ADDENDUM NO. 2

March 10, 2023

RAILROAD SPUR EXTENSION AND TRANS-LOAD FACILITY

Cole County Project No. 2022-701-1

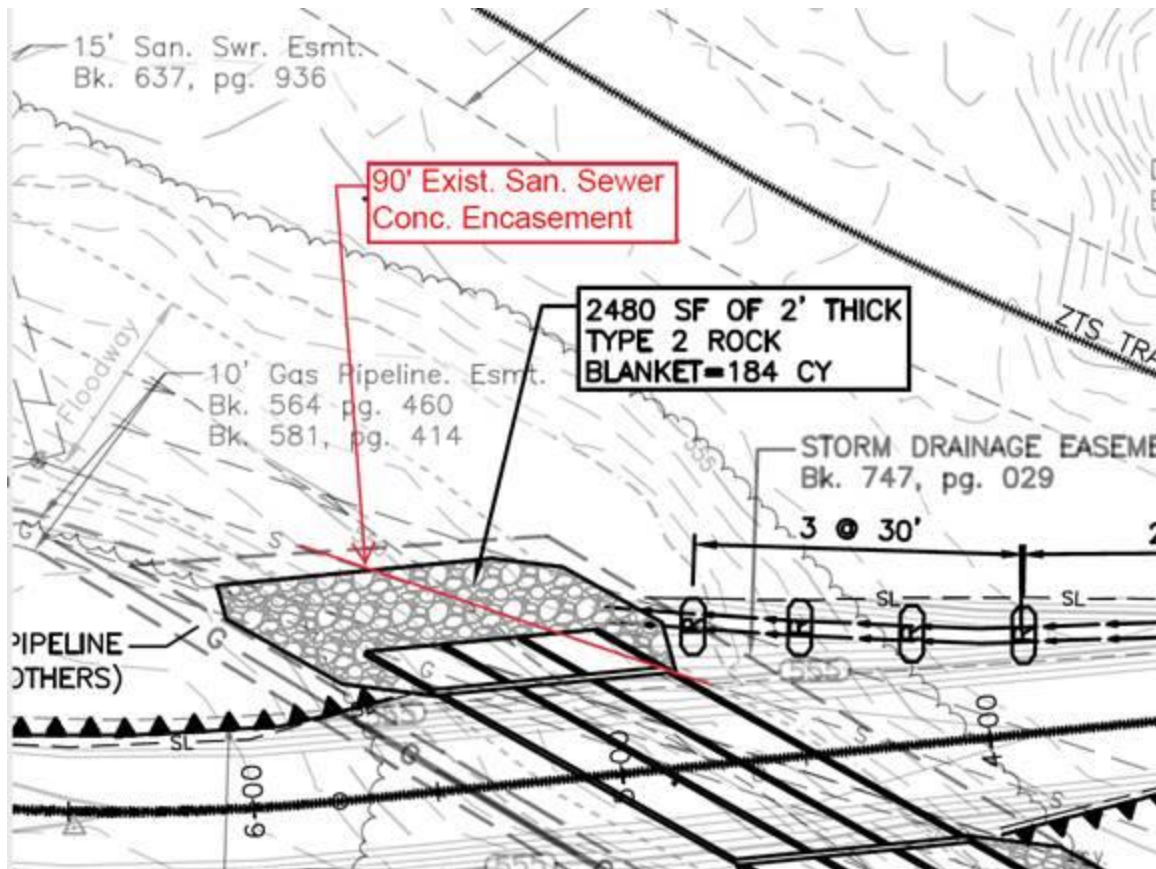
Q: There is a note shown on the box culvert drainage profile that we are to encase 90 LF of an existing 10" Sanitary Sewer Main, but I do not see this called out anywhere else in the plans or specifications? Please clarify.

A: Concrete encasement shall be a minimum of 24"x24" and shall be poured around existing sanitary sewer main as shown below:

AMERESCO		
ALIGNMENT SHEET		
JEFFERSON CITY PIPELINE RELOCATION PROPOSED 10" HDPE PIPELINE		
DRAWN BY: FM	DATE: 02/20/23	STA 0+00
CHECKED BY: JA	DATE: 02/20/23	STA 4+30
APPROVED BY: JA	DATE: 02/20/23	SCALE: 1"=30'
	DRAWING NO: 025570001-AFS-DW-P1101	REV: C

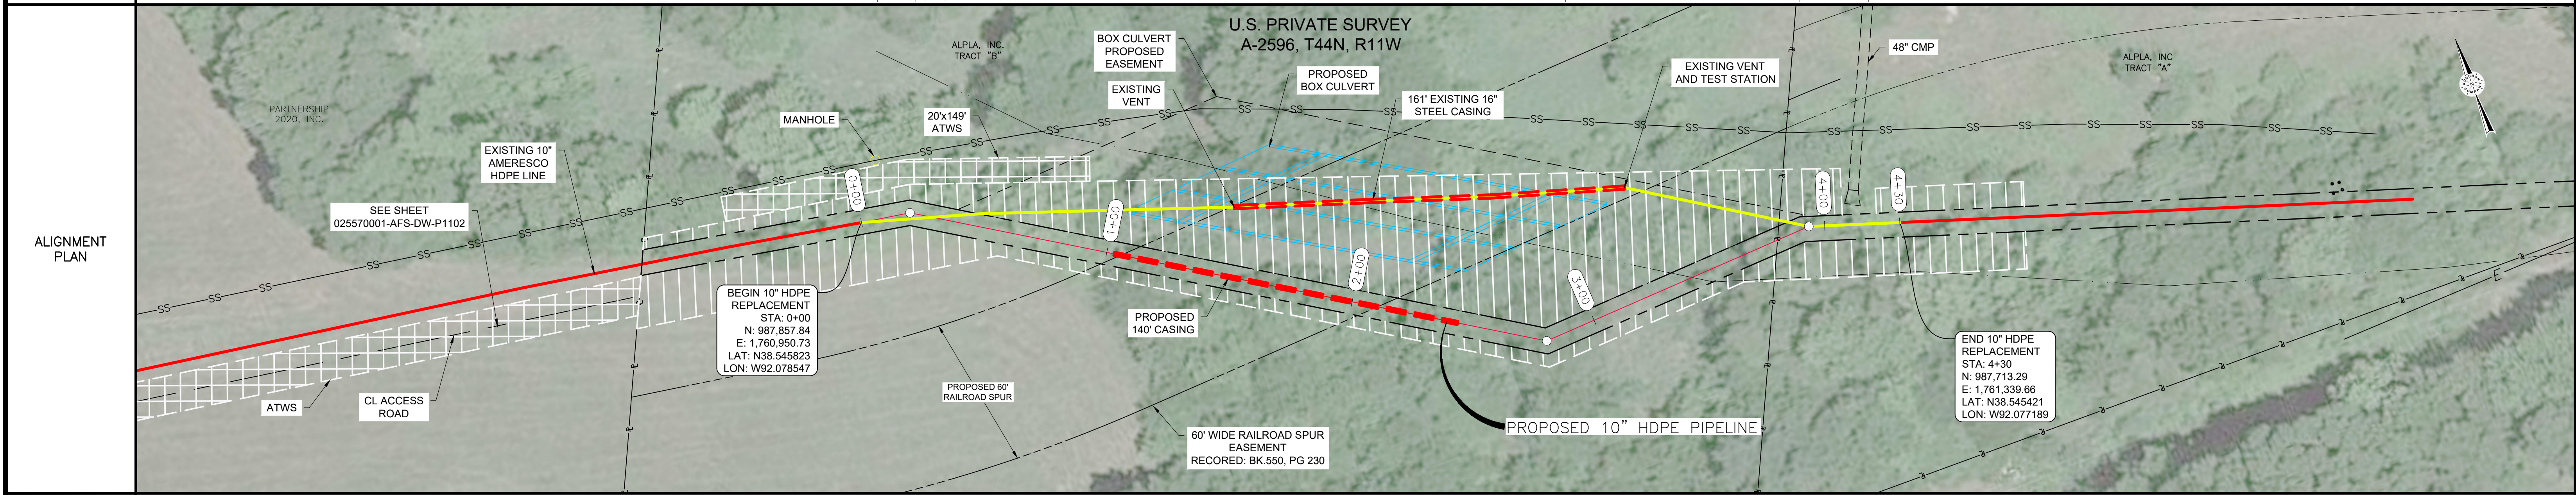
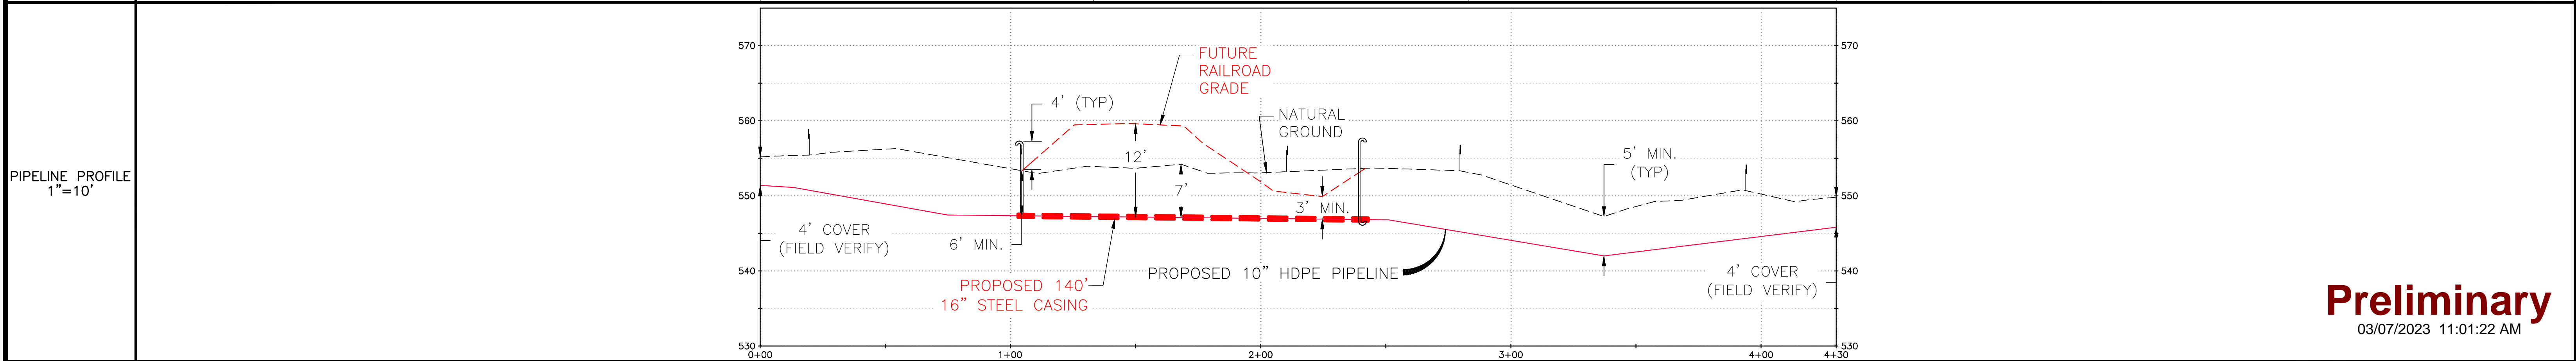
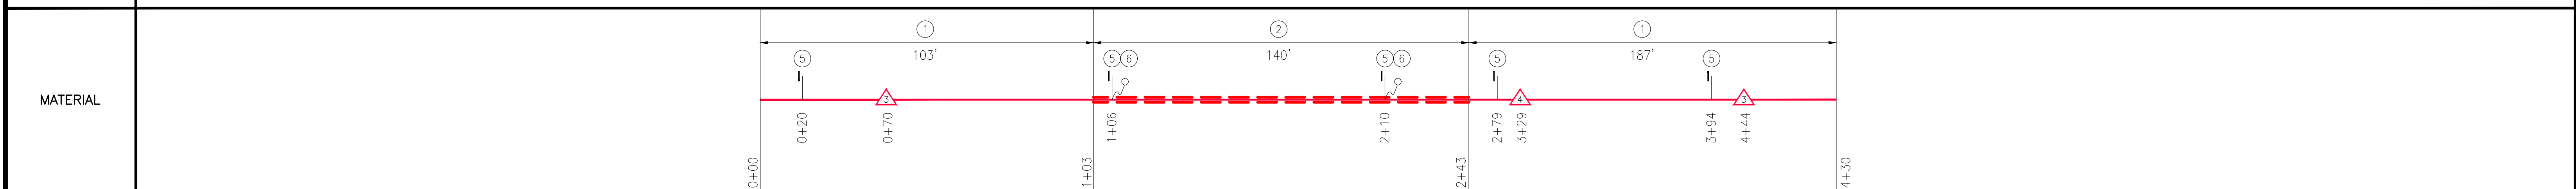
Ameresco Relocation:

Ameresco is responsible for relocating the existing methane gas main near Track A Sta. 5+00. The existing 10" polyethylene methane gas main and 16" steel casing will be purged of methane and abandoned in place. As part of the box culvert construction, the contractor shall remove any of the existing gas main and steel casing exposed during the excavation for the compacted shot rock subgrade. The contractor shall contact Ameresco prior to removing gas main to confirm absence of methane. The contractor shall be responsible for disposing of removed gas main and steel casing. All costs incurred by the contractor by complying with this provision shall be included in the lump sum price bid for "REINFORCED CONCRETE BOX CULVERT" Ameresco existing As-built plans and proposed relocation plans are attached to this Addendum.
